Technical Note

1.1 Mayer Brown Ltd has prepared this Technical Note in response to the most recent consultation response from Hampshire County Council, dated 27th May 2021, within their role as local highway authority (LHA) and relating to the Transport Assessment (TA), subsequent Addendums and Travel Plan submitted as part of Havant Borough Council planning application APP/20/01221 for the proposed construction of a Lidl foodstore on land adjacent to the B&Q store on Purbrook Way, Havant.

title
**PROPOSED LIDL FOODSTORE
PURBROOK WAY, HAVANT**

drawing number **B/LIDL PURBROOKWAY2.1/06** rev. **-**

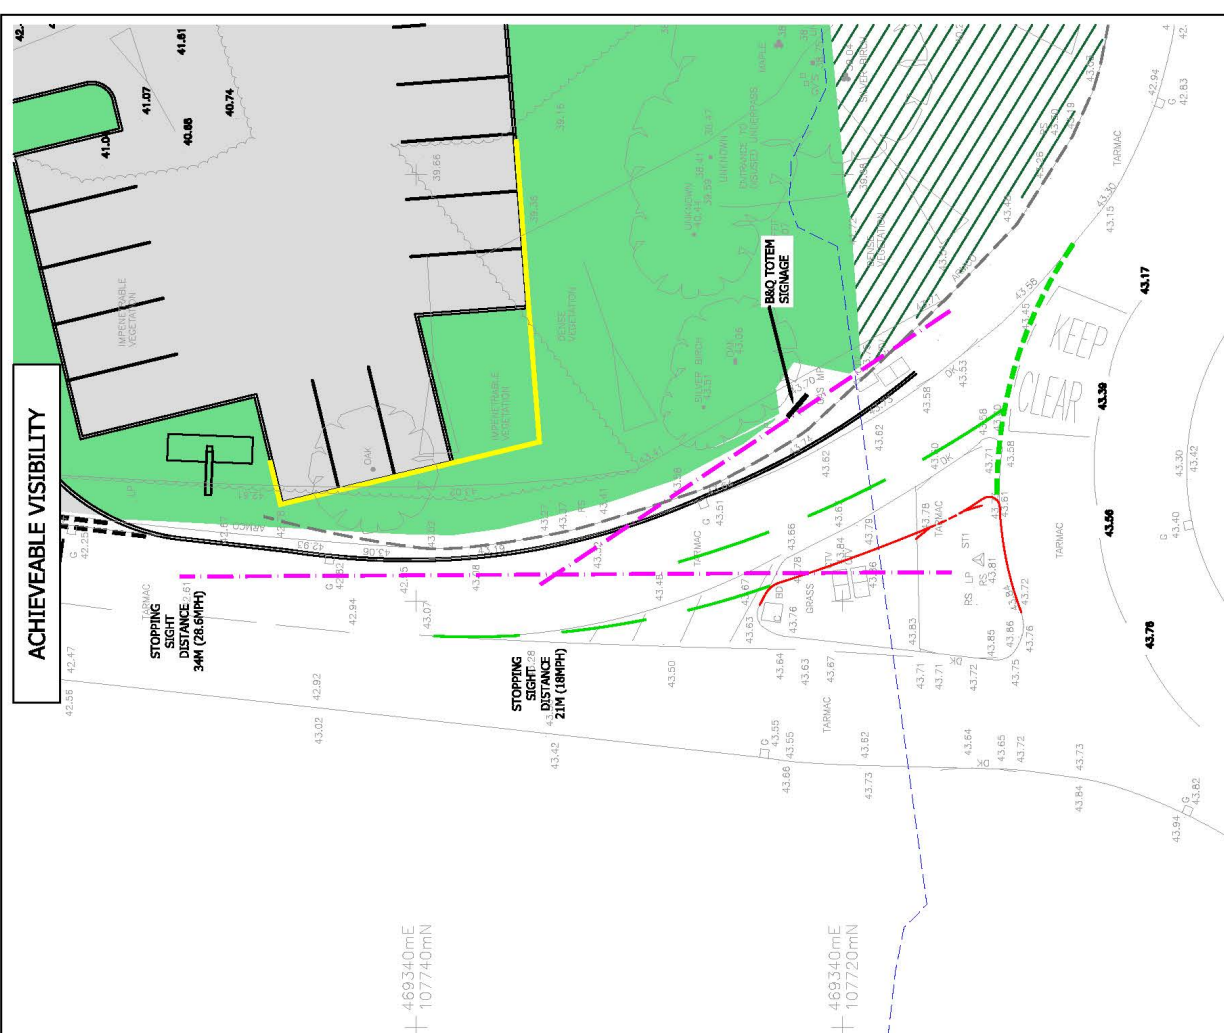
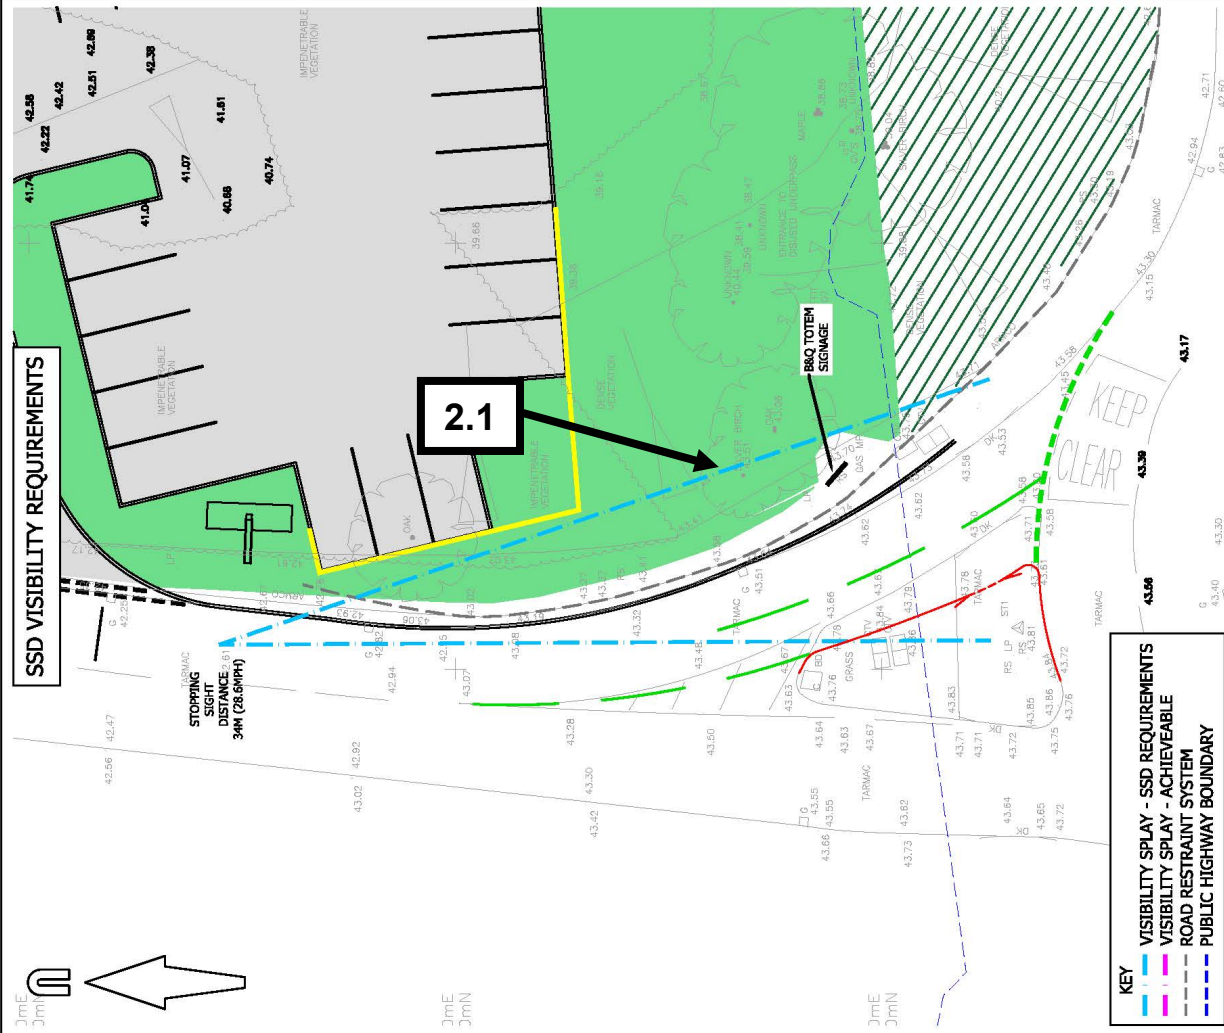
Whilst the Auditors accept that the B&Q totem sign will partially obstruct forward visibility splays to the pedestrian crossing point, the Auditors consider that if vegetation is trimmed back to provide the SSD visibility splays indicated on the drawings provided and maintained clear of vegetation, then this would significantly increase the margin of safety at the roundabout junction.

Details of tactile paving provision have not been provided. It is important to provide tactile paving to aid vision impaired users across the B&Q access arm.

- 1.40 Consequently, based upon LTN 1/07 indicating a potential for a 14.5mph reduction in observed speeds, it is proposed to provide 1.9m wide speed cushions on the B&Q egress carriageway for a length of around 150m, with a cushion placed c. 30m back from the roundabout give-way line and then at 40m spacings, resulting in 3 speed cushions being provided in total. An indicative plan showing planned traffic calming improvements is provided in **Appendix J**.
- 1.41 Based on an existing 85th percentile speed of 28.6mph, it is envisaged that the proposed traffic calming could potentially achieve speeds nearer to 14 - 18mph, within achievable SSD visibility splays for the western crossing point (21m / 18mph 85th percentile speed).

scale 1:250 @ A3	drawn by RB	checked by -
date JUNE 2021	cad file 210706 - B&Q ARM VISIBILITY	
drawing number B/LIDLPURBROOKWAY2.1/07-01	rev. -

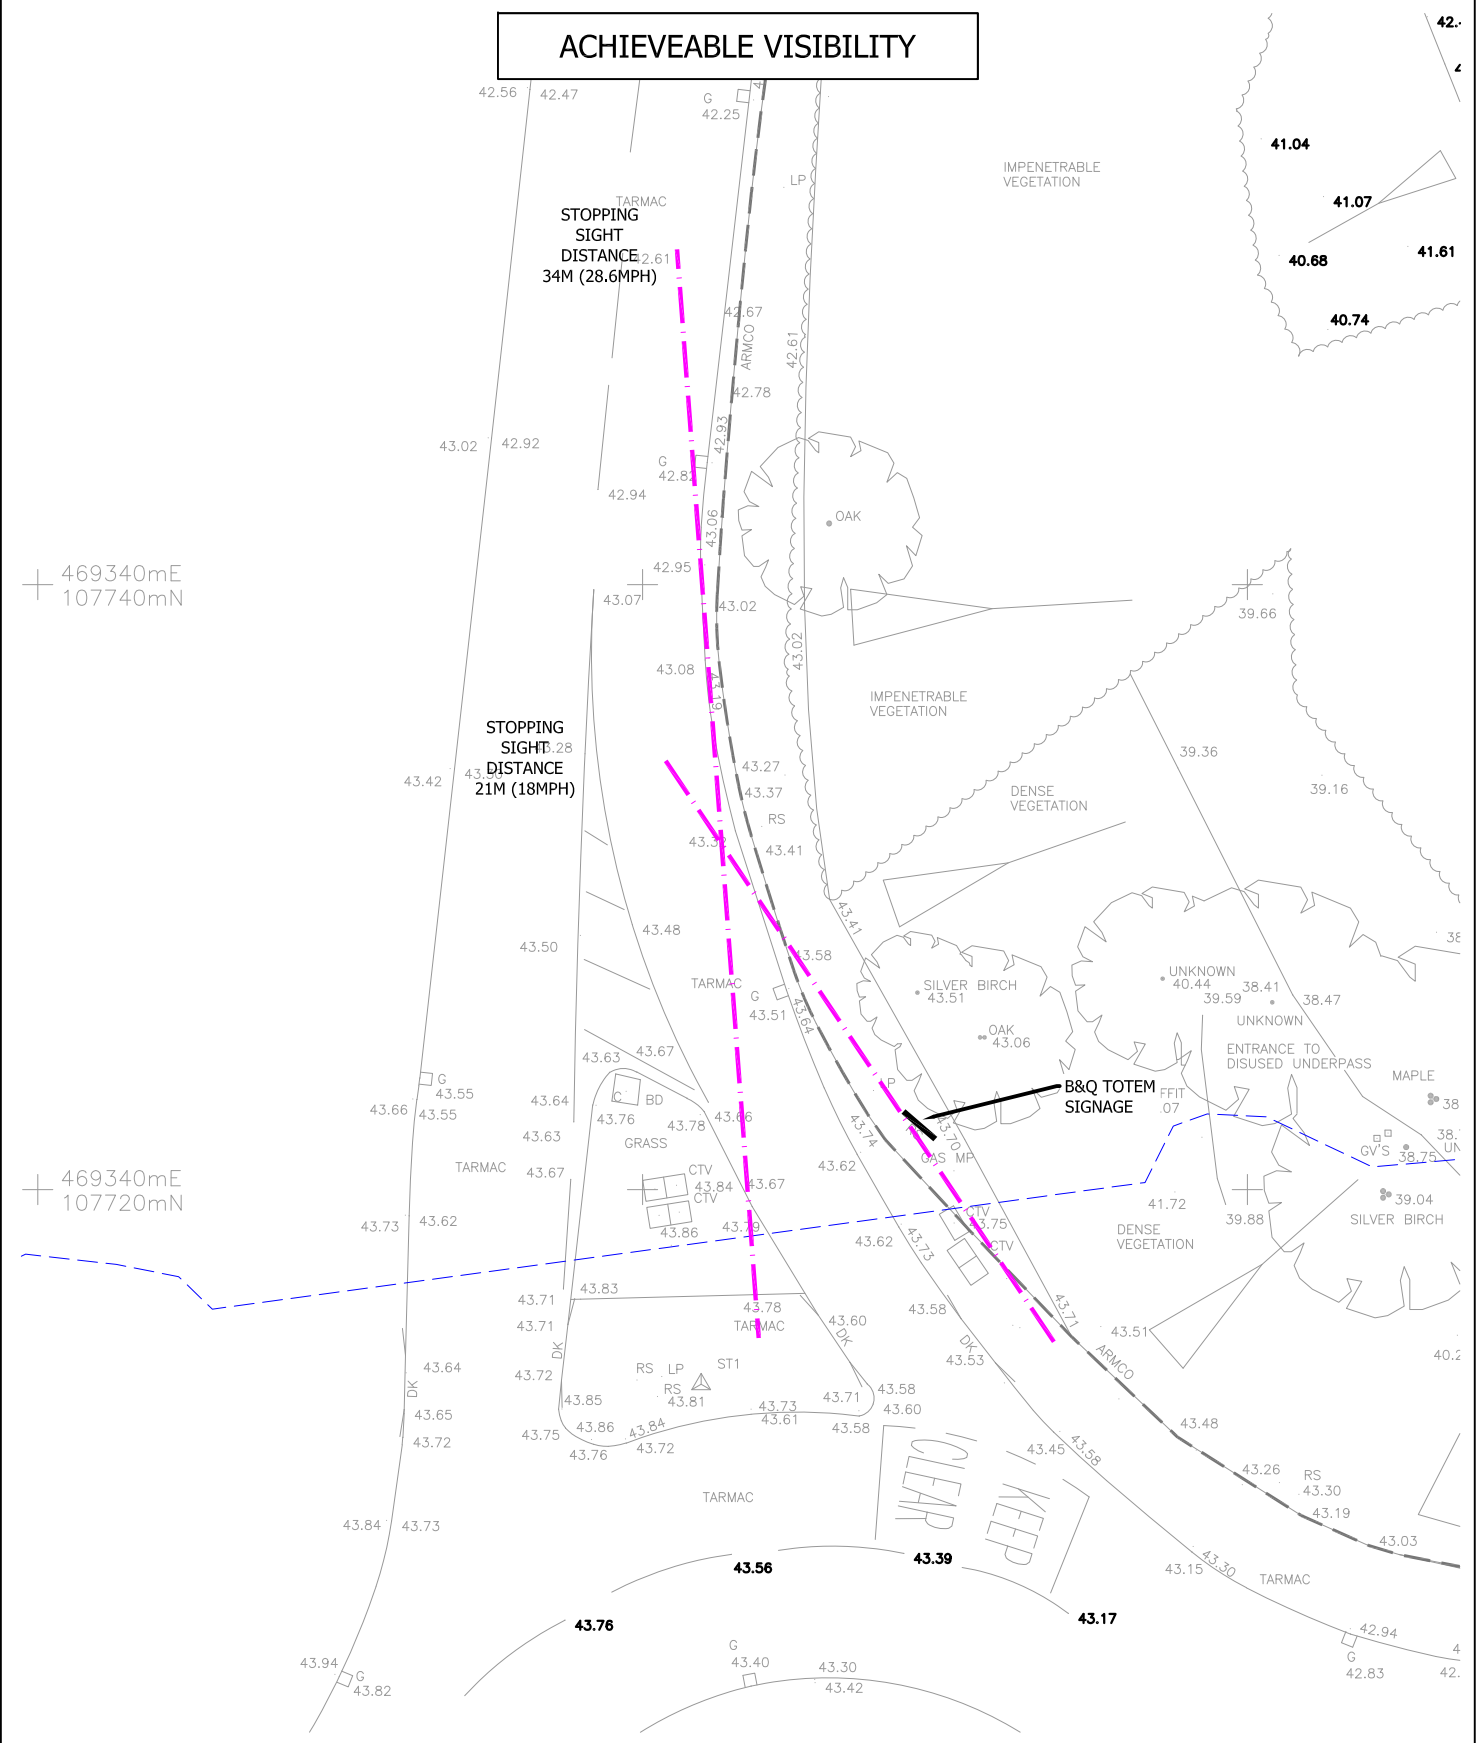
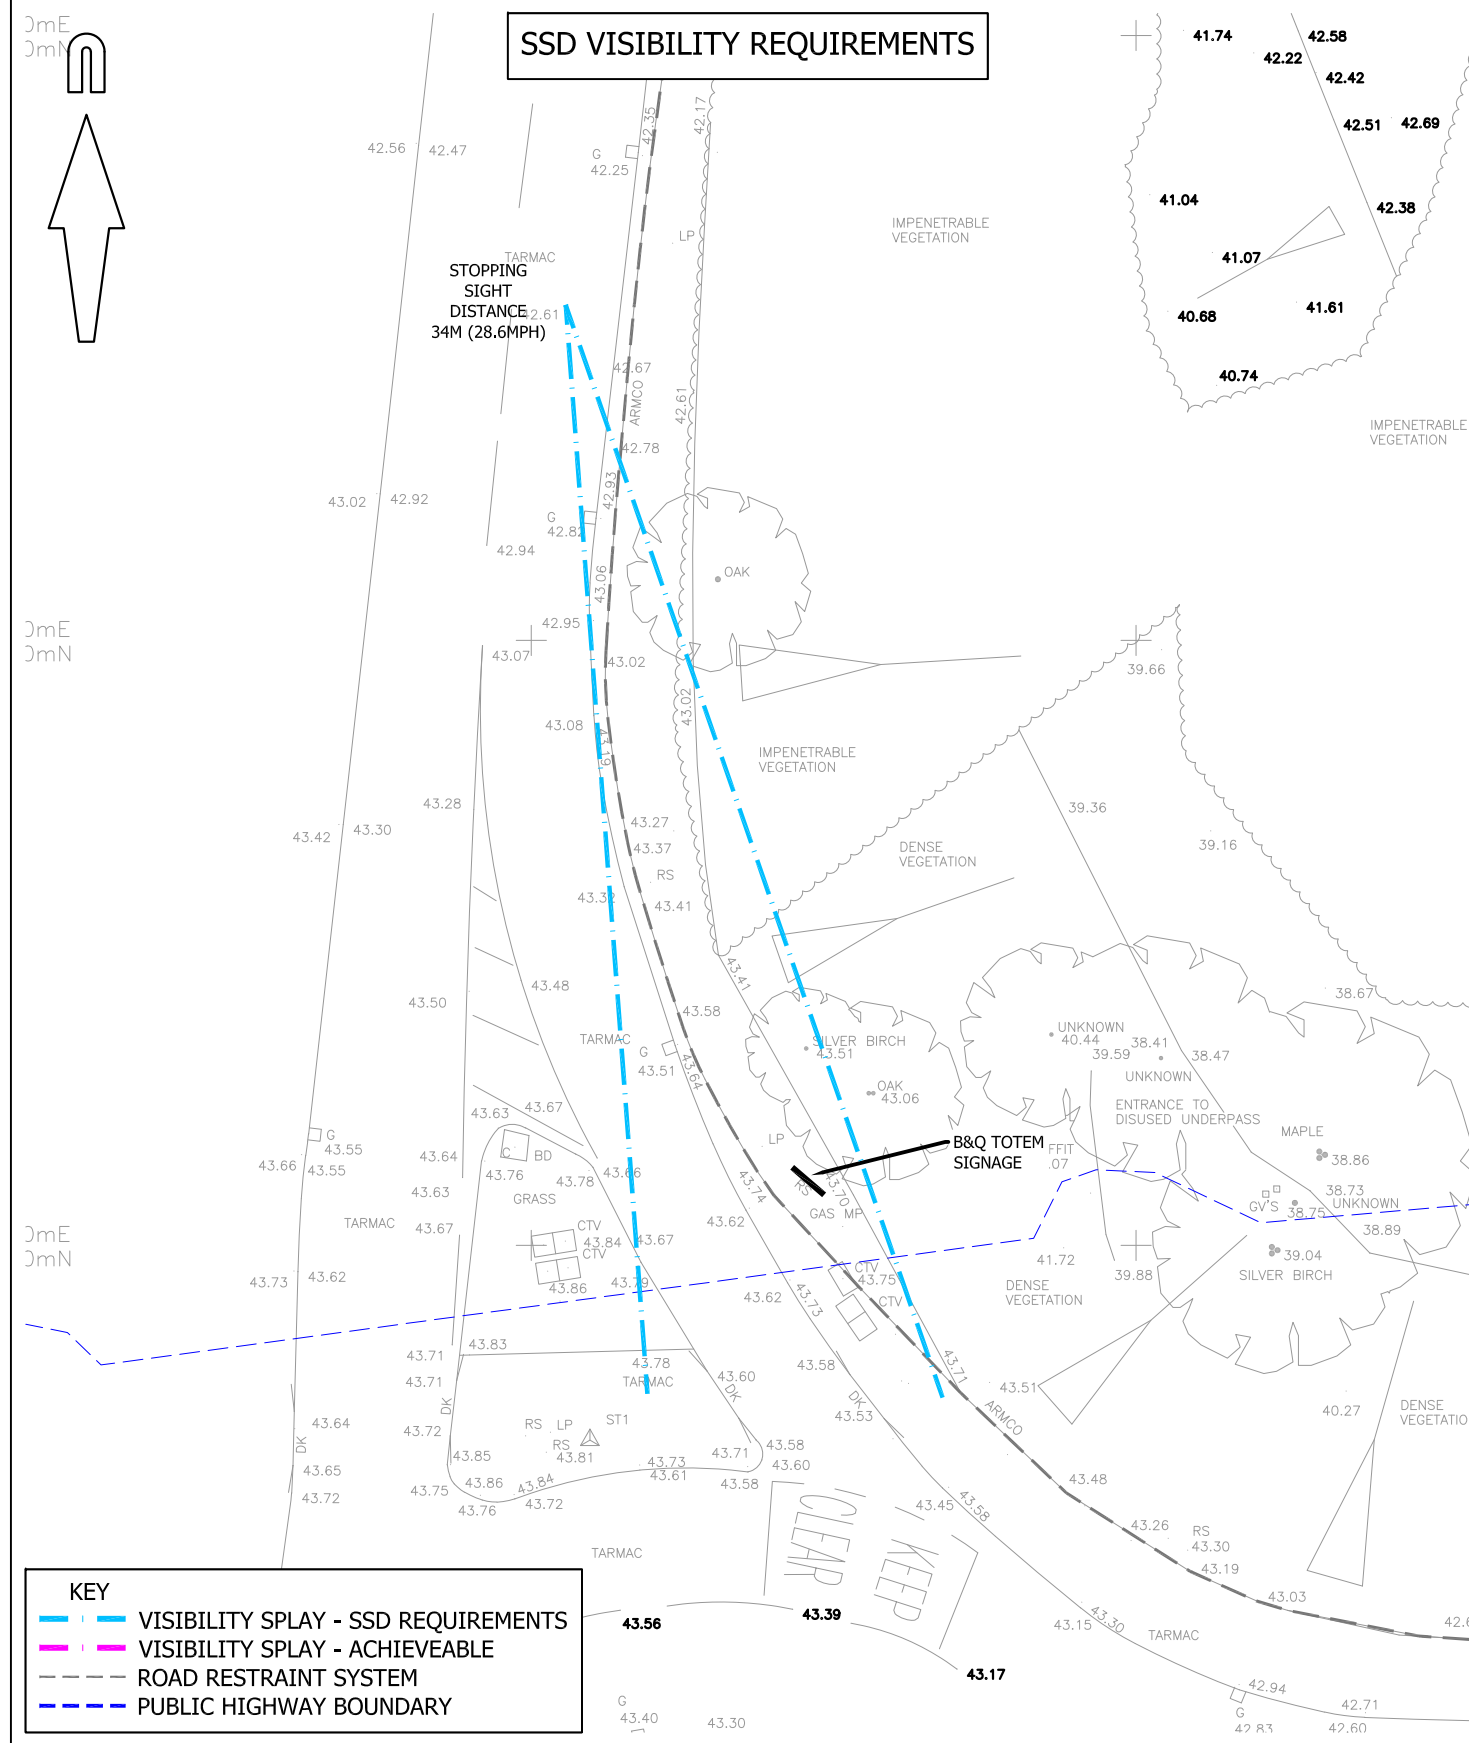
To demonstrate the additional visibility afforded by the vegetation removal, the applicant has provided drawing number B/LIDLPUROBROOKWAY2.1/03. Whilst the drawing demonstrates that the intervisibility will be improved, there remains approximately 10m in-between the existing and proposed extension of the intervisibility which is blocked by the location of the B&Q sign.

The plans and the Audit Brief provided for Audit set out the SSD visibility splays in accordance with 'HCC Technical Guidance Note TG3'. These splays are currently obscured by over-growing vegetation and a B&Q totem sign which the Auditors are advised "sits on third party-controlled land, sitting outside land within the control of applicant and the local highway authority."

- 1.32 A review of the existing crossing point arrangement indicates that it provides appropriate visibility for pedestrians based on a 24m SSD and for cyclists based on a 21m SSD. Consequently, the existing achievable SSD's are equivalent to 85th percentile speeds of 20mph for pedestrian visibility and 18mph for cyclist visibility.

- 1.33 The achievable horizontal visibility is currently limited by the existing B&Q totem, situated on third party land outside of the control of the applicant and LHA, in addition to adjacent vegetation / trees located along the eastern side of the B&Q arm.
